# 6th Avenue North Apartments

DCI PROJECT #3022764

RECOMMENDATION PACKET

REC MEETING, MAY 17, 2017

# ITEMIZED RESPONSE TO EDG

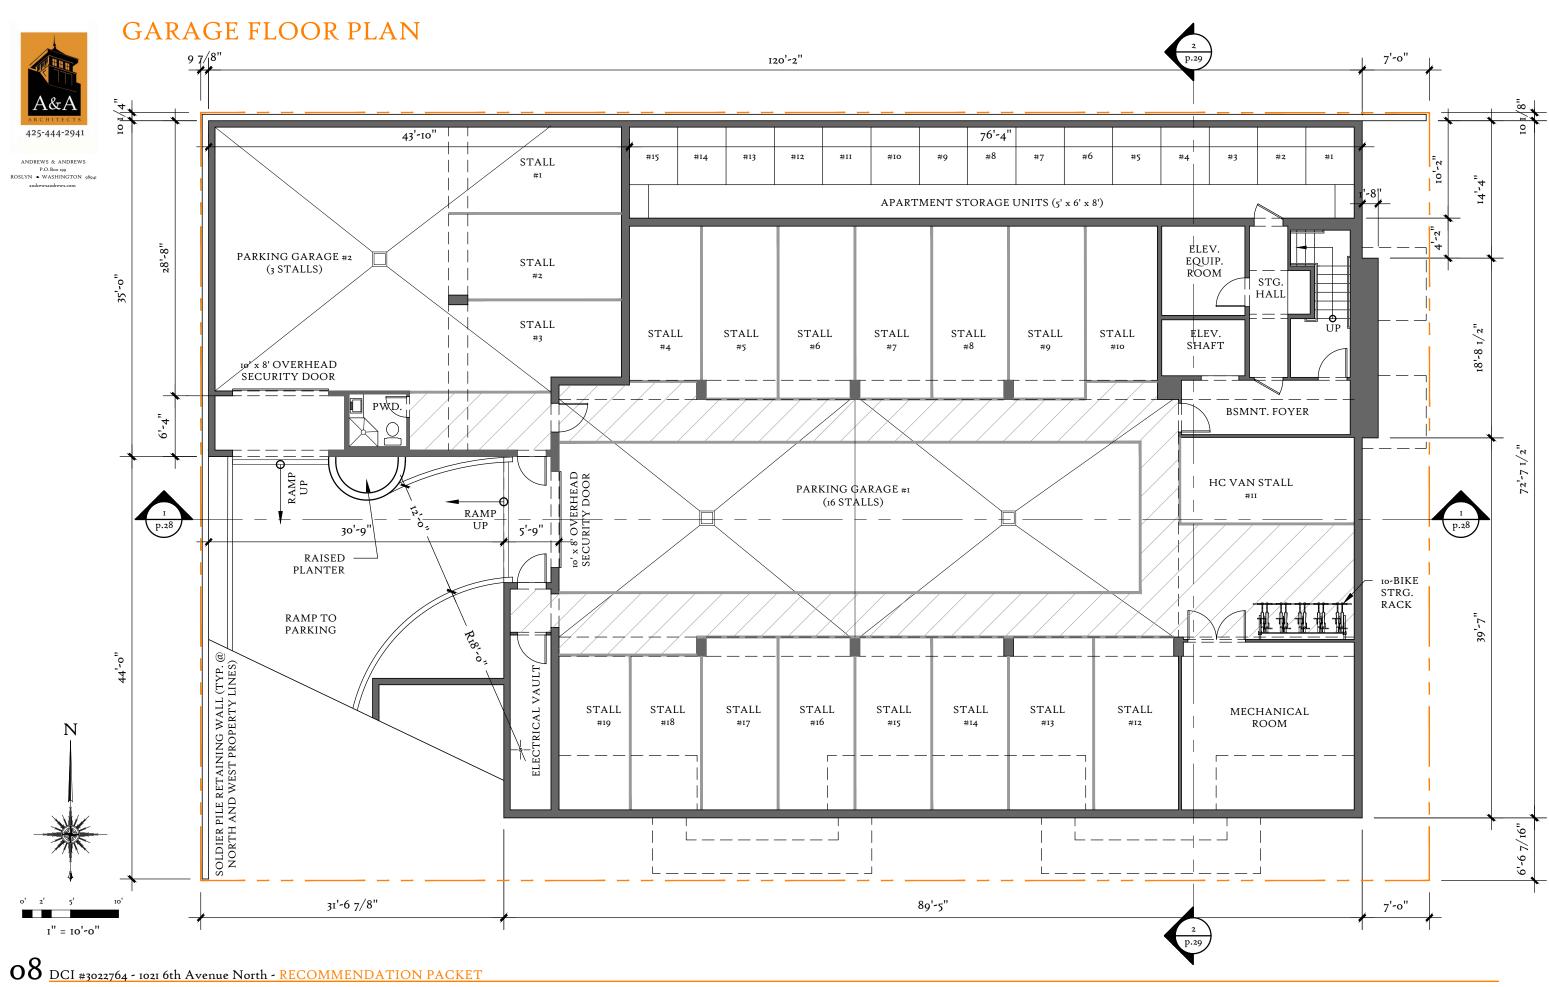
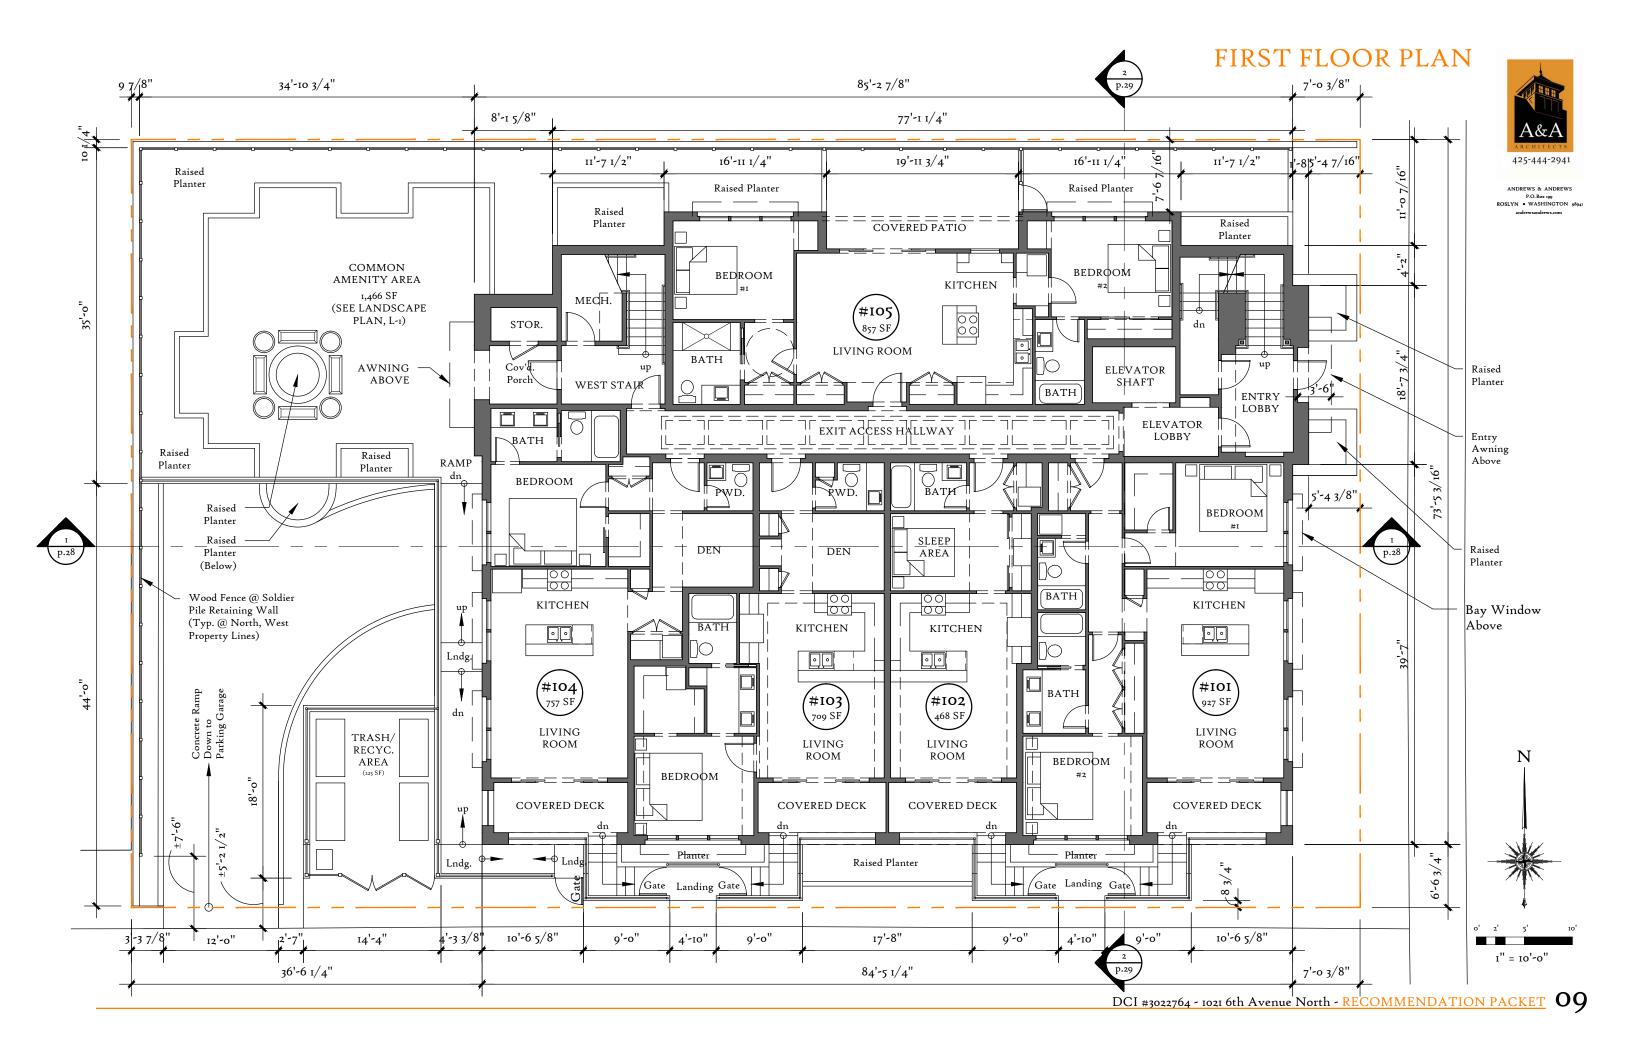
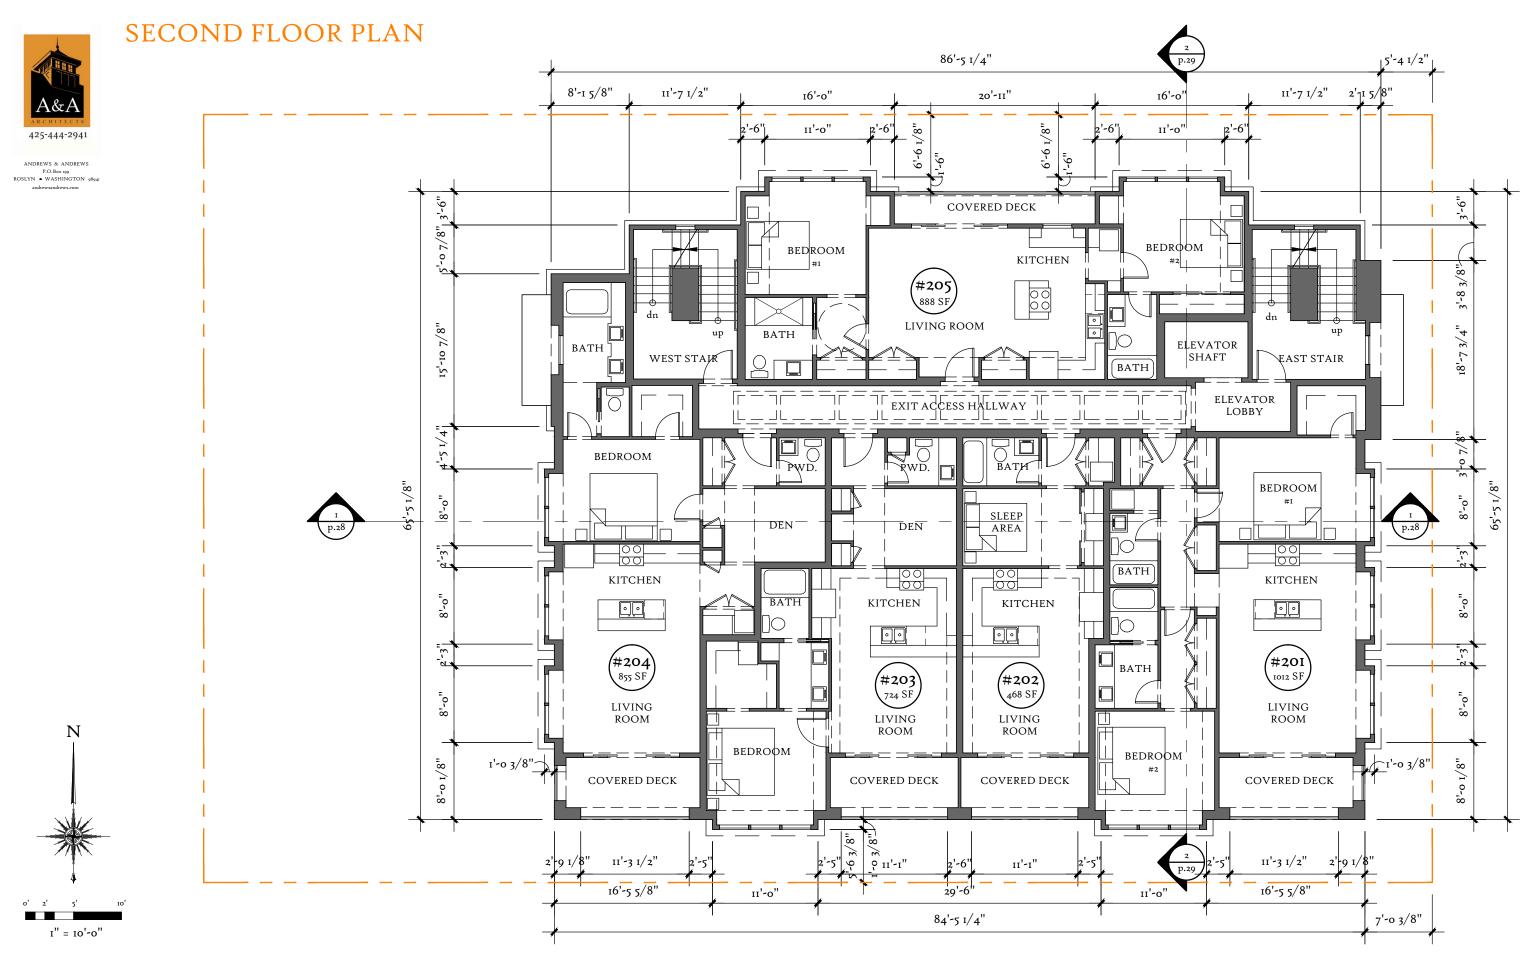
f. The dumpster should be either be screened or located in the basement.(DC1-C4)	f. Applicant increased the trash enclosure setback from the alley, and screened it with a concrete wall along the back and sides, and a metal mesh fence along the alley.		c. A greater northern setback and a landscape buffer should be explored to minimize privacy impacts for the home to north. (CS2-D1 & 5)	c. Applicant eliminated the exterior porches at the northeast and northwest corners of the building, moved the whole building one foot south, and set back the main north building wall 11' from the property line. Two window bays and a narrow central deck project from the main wall to the setback line. The north setback is now 7'-6" from the property line, leaving approximately 16'-10" clearance

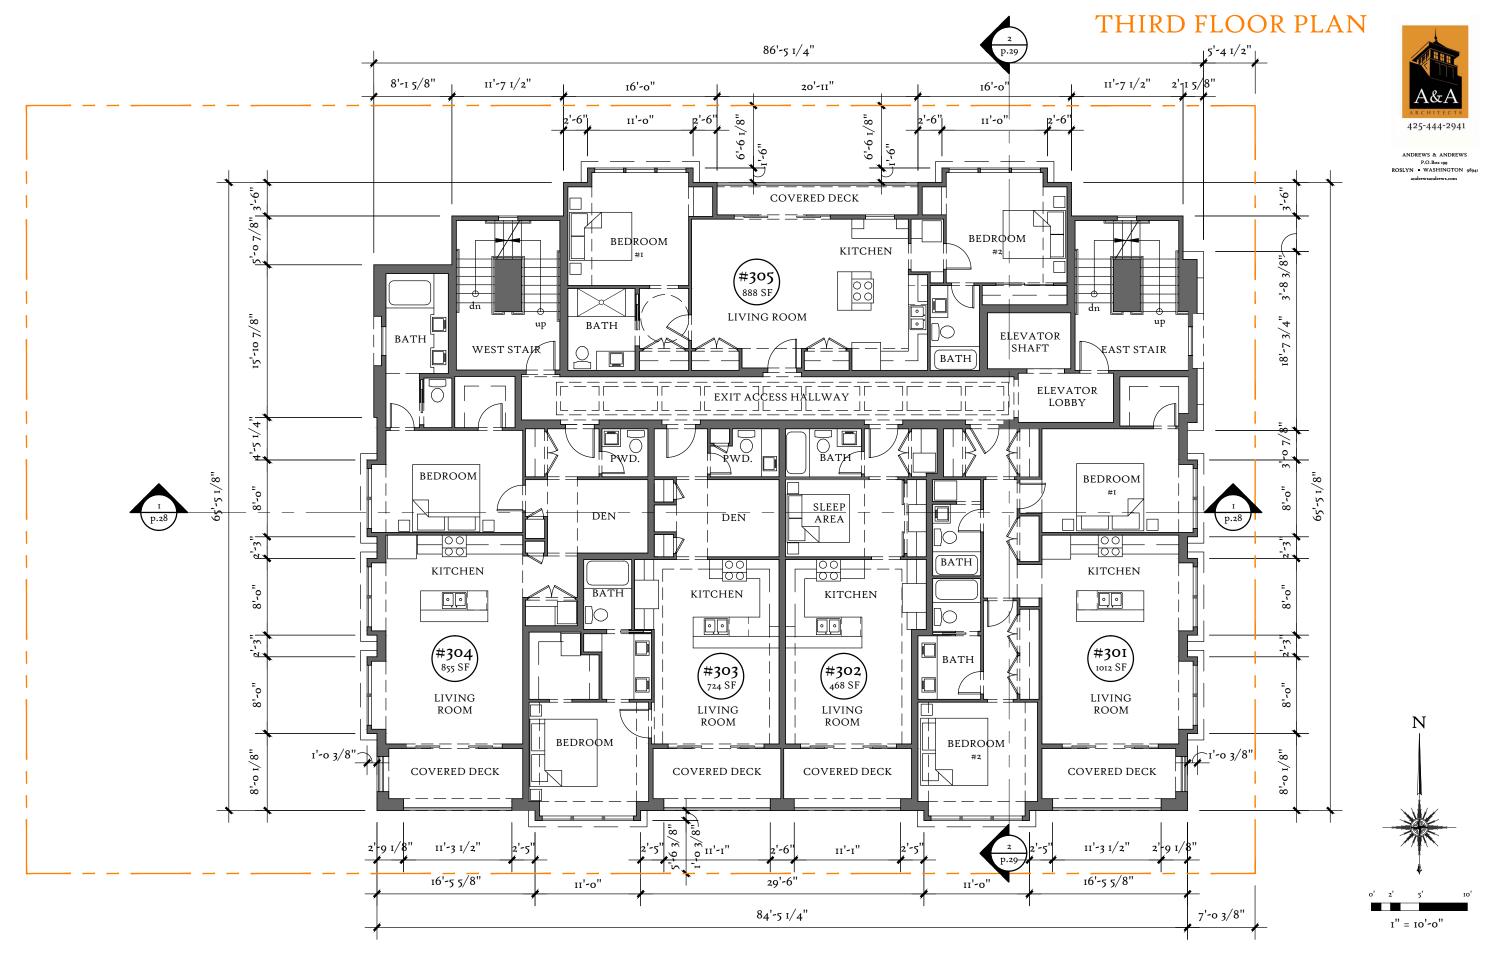
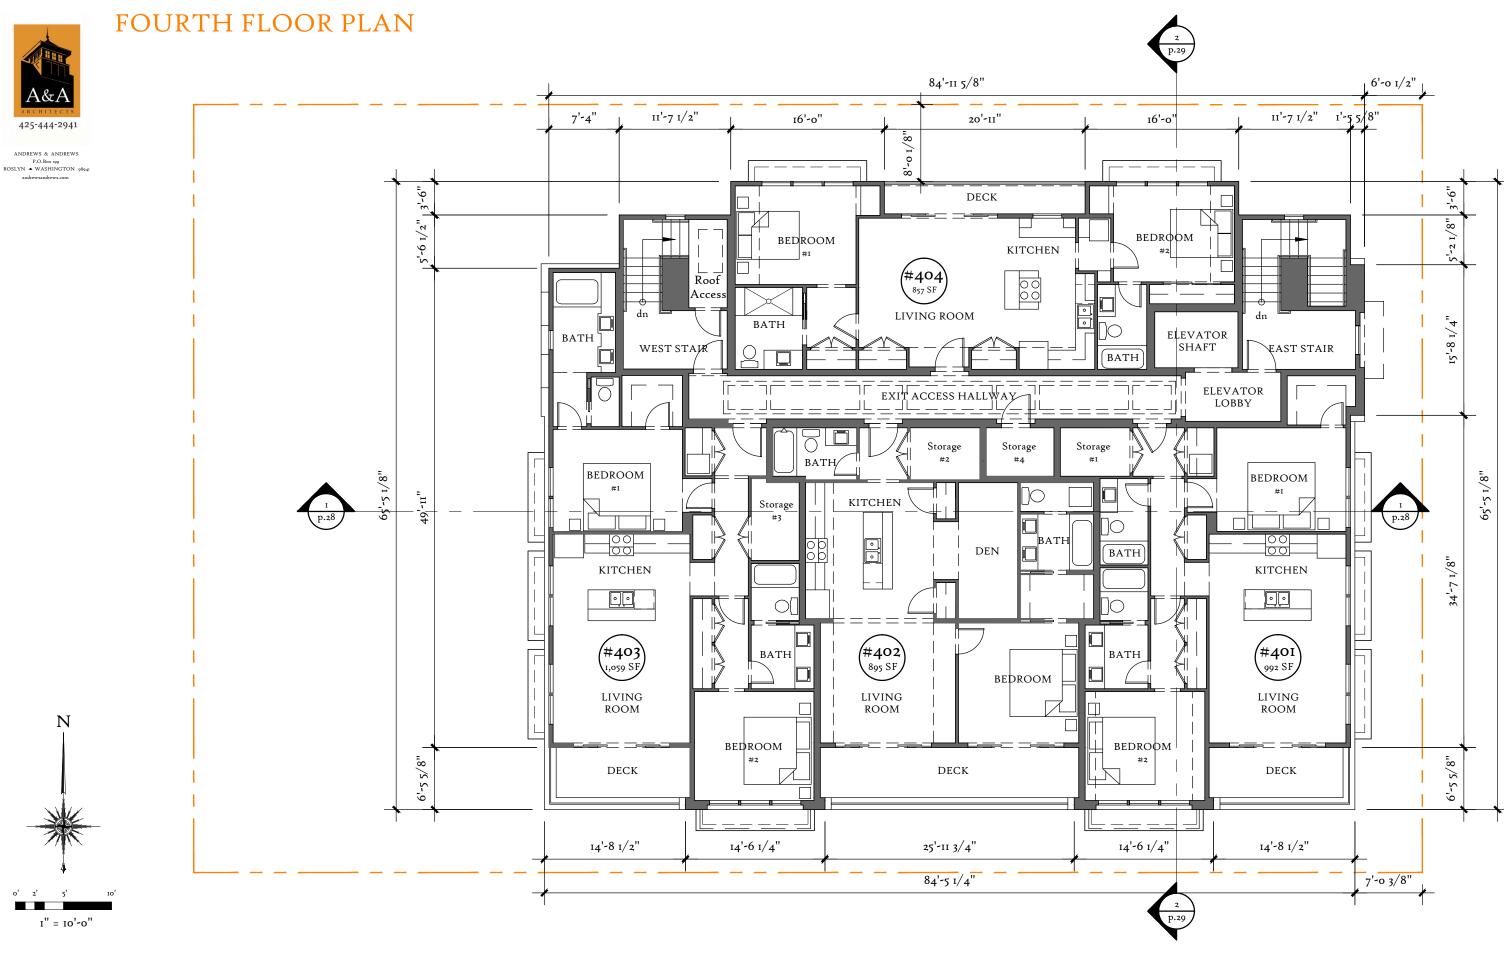
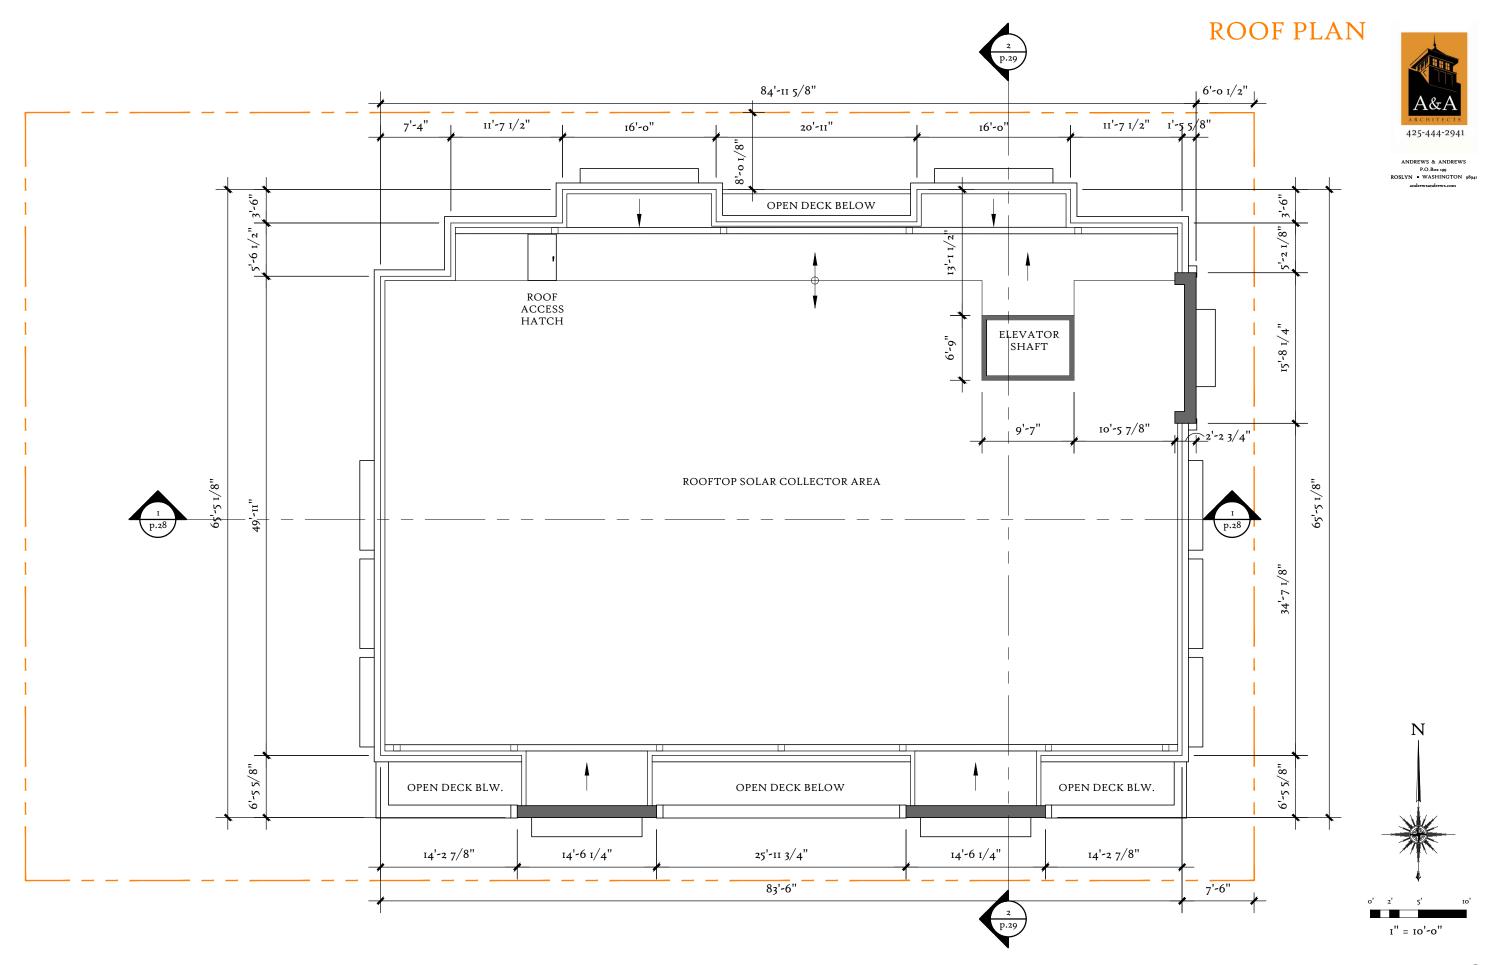
g. The Board encourage exploring lidding over the drive ramp to add to the amenity space and reduce noise from the underground parking garage. (DC-B1)	ramp an additional 5', to reduce			between existing and proposed buildings at their closest point. This north setback will be a continuous planted landscape buffer, with a 4' wood fence set on top of a continuous shoring wall. See Landscape Plan, page 14.	
CONTEXT:  a. The Board noted the project responded well to existing buildings and the overall neighborhood. At Recommendation, the applicant should provide a window study for further privacy analysis.	CONTEXT: a. See Window Study on Page 23.	See Window Study on Page 23.	d. Larger trees should be used around the entire site to create a more layered landscaping plan as outlined in the Uptown Guidelines. (Uptown DC3-I.i)	d. Applicant added western hemlock, maple, tulip and ginkgo trees in response to the EDG request for taller trees in the layered landscape.	See Landscape Plan on Page 14.

b. The rooftop amenity should be moved to the south and screening elements such as landscape planters should be located on north side to prevent residents from congregating near the north edge. (DC3-B1)	b. Applicant eliminated the rooftop amenity area, due to safety, cost and noise concerns. The Proposed Roof will have only solar panels, with a Maintenance Hatch accessed from the Fourth Floor West Stairway.		e. The ground level Common Amenity Area should be passively programmed to minimize noise and convey the sense of open space around the building. (DC3-B1)	e. To encourage quiet, peaceful contemplation in the ground floor exterior Common Amenity Area, the Applicant added a raised planter in front of the wood fence along the north and west borders, placed individual benches around a central planter to discourage group gatherings, and provided pavers in the courtyard rather than grass. There will be no public barbeque.

#### 2. DECORATIVE PARAPET HEIGHT (See Pgs. 32-33)

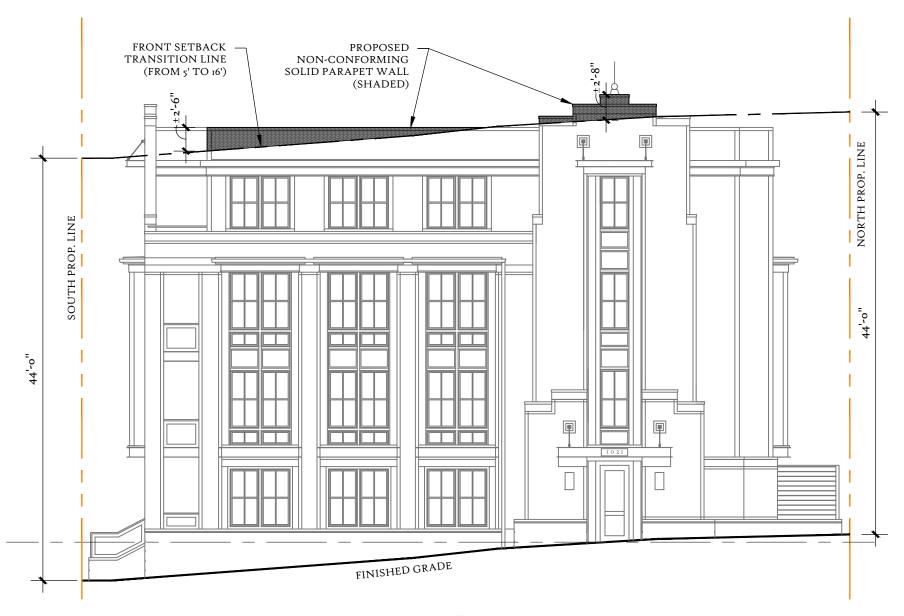
DEPARTURE DESCRIPTION:	CODE REQUIREMENT (SMC23.45.514.J.2):	PROPOSED DEPARTURE:	RATIONALE:
TO ALLOW DECORATIVE STEPPED PARAPETS TO EXCEED MAXIMUM PARAPET HEIGHT.	Parapetsmay extend 4 feet above the maximum height limit.	Decorative stepped brick parapets on the south elevation exceed maximum parapet height by a maximum 1'-6", over a maximum 9'-0" length (2 locations).  The decorative brick parapet above the main east entry exceeds the maximum parapet height by a maximum 2'-6", over a maximum 9'-0" length.	apartments in the neighborhood.  B. The extra height at the south and east parapets will not
